Technical Service Bulletin

Subject: RATTLING NOISE FROM LIFTGATE WHEN DRIVING	Bulletin No.: 09-020/25
	Last Issued : 04/23/2025

2024-2025 CX-90 with VINS lower than JM3KK*****224789 (produced before January 7, 2025)

2025 CX-70 with VINS lower than JM3KJ*****122126 (produced before January 7, 2025)

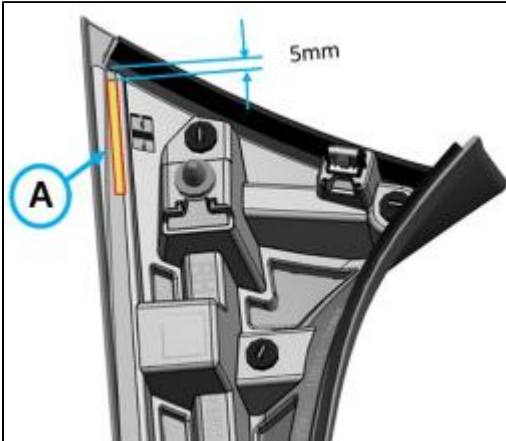
3. Attach the High-Density Urethane Pad to the rear side spoiler.

a. Cut the High-Density Urethane Pad to make a 50 x 5 mm pad.

b. Remove grease from the pad attachment area and then attach the pad to (A) indicated in the image

NOTE: The pad must be attached on the flat surface, right next to the curved surface.

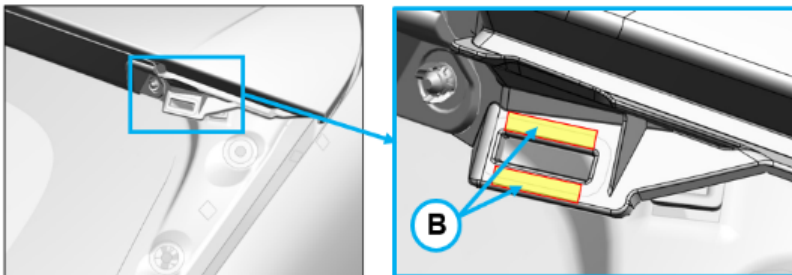
4. Attach the felt sheet to the rear spoiler.

a. Cut the felt sheet into 2 pieces, each measuring 20 x 5 mm.

b. Remove the grease from the sheet attachment areas and then attach the sheets to (B) indicated in the image.

NOTE: The sheets must be attached on the flat surface, right next to the curved surface.
